## Plan Review Results

Comments in Red Box were previously provided as part of Foundation Permit.  
Comments in Blue Box are provided Feb 8, 2013, as part of New Building Permit.

## Summary of Comments on Building Department Notes and FEMA Map

Page: 94

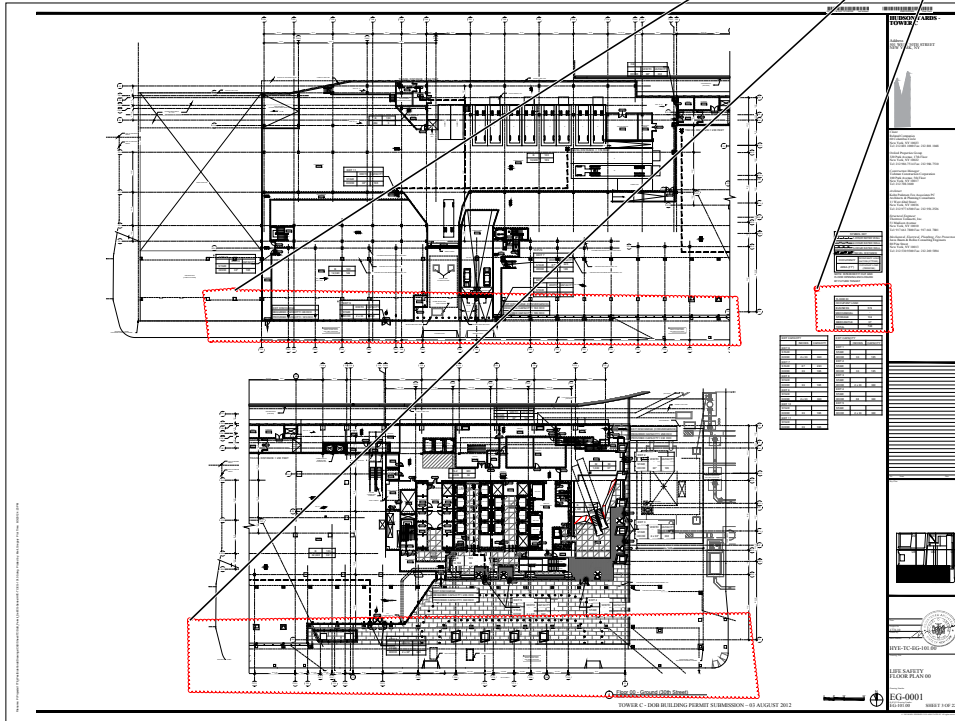
- Author: dtitus Subject: Polygon Date: 9/7/2012 9:38:22 AM  
Provide net area of space based on (?) sq. ft./person as per table 1004.1.2 BC (TYP for all occupant load calculation).
- Author: dtitus Subject: Polygon Date: 9/7/2012 12:37:46 PM  
Provide fire protection of openings in exterior walls as per (BC 704.8, BC 705.8, BC 715.4).
- Author: dtitus Subject: Polygon Date: 9/7/2012 12:37:52 PM  
Provide fire protection of openings in exterior walls as per (BC 704.8, BC 705.8, BC 715.4).

Area and occupant load summary have been provided on each EG-series plan.

Doors swing in direction of egress.

On western plaza, no use is proposed. Access to stair tower only.

Fire protection of openings not required. West 30th street is mapped 60' wide, with property line 30' from street centerline.

Page: 95

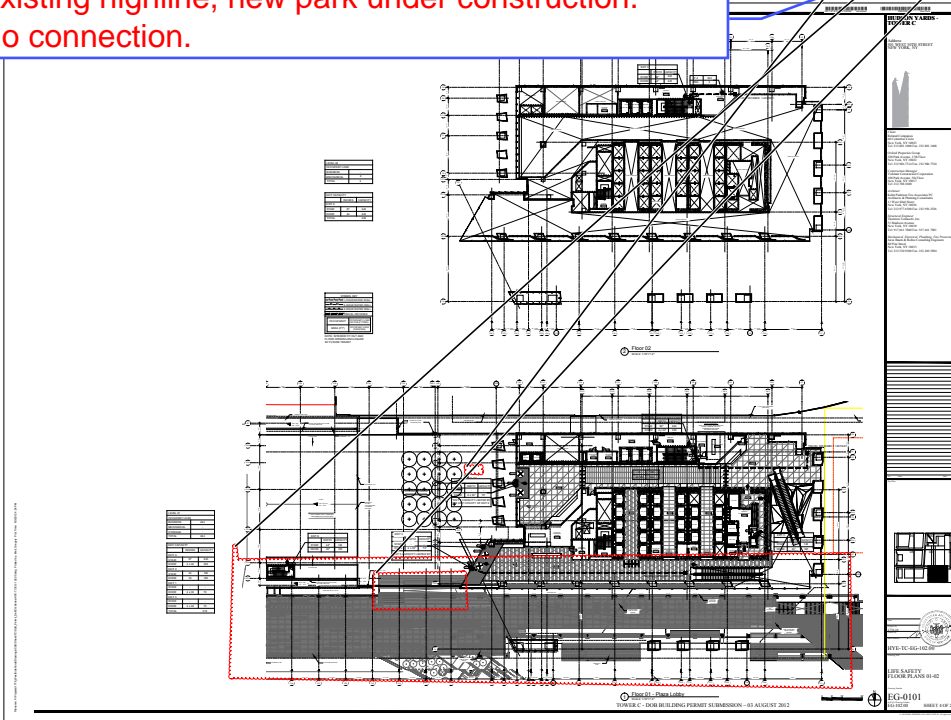
- Author: dtitus Subject: Polygon Date: 9/7/2012 1:11:31 PM
- \* Provide net area of space and number of persons to be accommodated based on (?) sq. ft./person as per table 1004.1.2 BC
- \* exit doors from Plaza shall swing in the direction of egress as per BC 1008.1.2.2
- \* Provide commissioner approval for unlisted occupancy as per BC 1004.1.5.
- Author: dtitus Subject: Polygon Date: 9/7/2012 12:38:25 PM
- \* Provide fire protection of openings in exterior walls as per (BC 704.8, BC 705.8, BC 715.4).
- Author: dtitus Subject: Polygon Date: 9/7/2012 1:17:46 PM
- \* Please clarify??

Existing highline, new park under construction. No connection.

For stair layouts including photo luminescent exit path markings, refer to A-400 series plans and details.

Page: 100

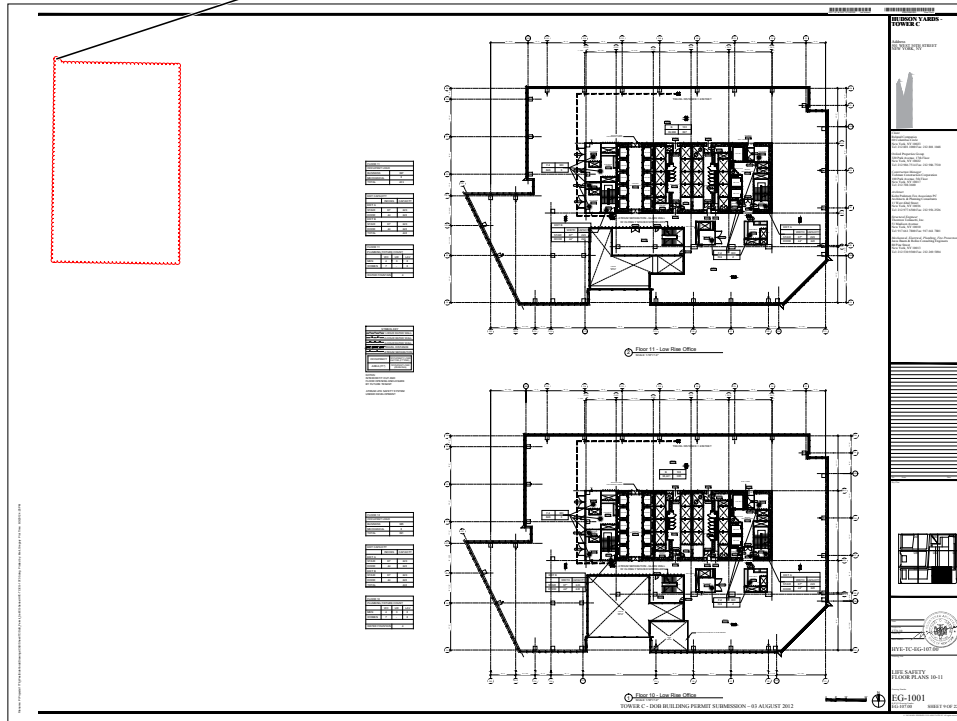
Author: dtitus Subject: Polygon Date: 9/7/2012 11:03:49 AM  
Provided stair details and sections to verify compliance with BC 1009.

- 1 Provide note describing stairway door operation and stairway communications system as per BC 403.12
- 2 Provide note describing smoke proof exit enclosures for compliance with BC 403.13.
- 3 Provide note describing impact-resistant stairs enclosures as per BC 403.15
- \* Indicate photo luminescent exit path markings as per BC 403.16.

- 1 SEE DEPARTMENT OF BUILDING NOTES ON B-SCAN DRAWING G-003.00. CAN PROVIDE FURTHER DESCRIPTION AS PART OF NB APPROVAL.
- 2 SEE DEPARTMENT OF BUILDING NOTES ON B-SCAN DRAWING G-003.00.
- 3 SEE DEPARTMENT OF BUILDING NOTES ON B-SCAN DRAWING G-003.00.

Page: 127

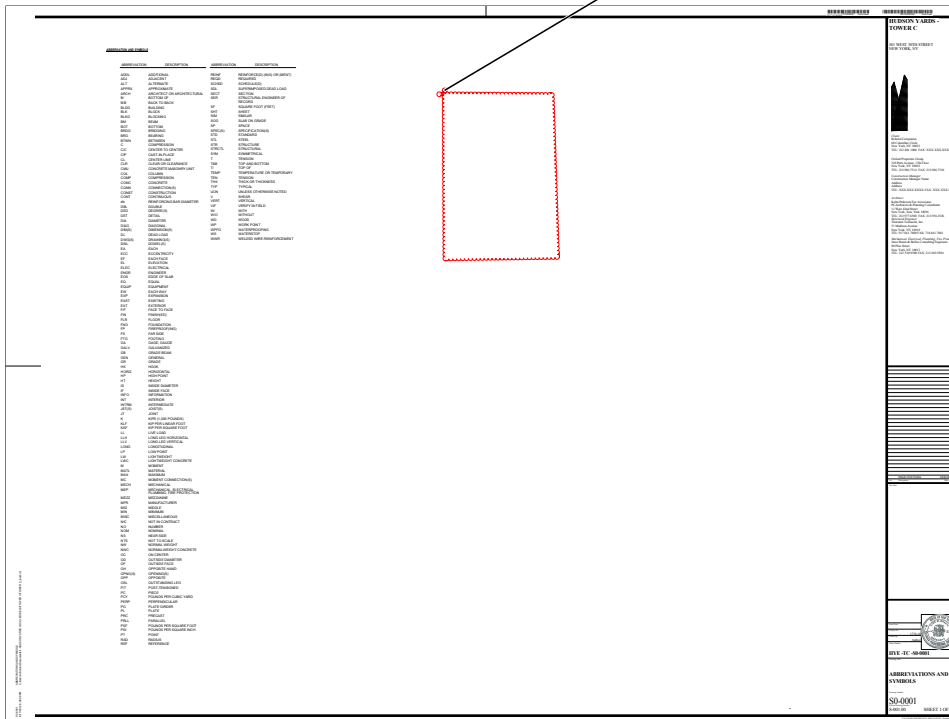
- 1 TR-1 for underpinning, sheeting and shoring with details as per BC 1704.9.1 & 1704.19
- 2 Provide note: notification to DOB 24-48 hours prior to commencement of earthwork as per BC 3304.3.1.
- 3 BC 1801  
BC 1805 Verify and provide compliance for foundation plans.
- 4 BC 104  
BC 1701 TR-1 for special /controlled/progress inspections: a) concrete, b) concrete test pits & c) concrete test cylinders
- 5 Provide structural peer review report as per BC 1627.

- 1 SEE NEW YORK CITY BUILDING DEPARTMENT NOTES ITEM #2 ON B-SCAN DRAWING SOE-001.00.
- 2 SEE NEW YORK CITY BUILDING DEPARTMENT NOTES ITEM #6 ON B-SCAN DRAWING SOE-001.00.
- 3 NOTES HAVE BEEN ADDED TO B-SCAN DRAWING S-003.00.
- 4 FOR SPECIAL INSPECTIONS SEE GENERAL NOTES SI-1 ON B-SCAN DRAWING S-003.00.
- 5 STRUCTURAL PEER REVIEW IS BEING PERFORMED. REPORT TO BE ISSUED PRIOR TO BUILDING PERMIT.
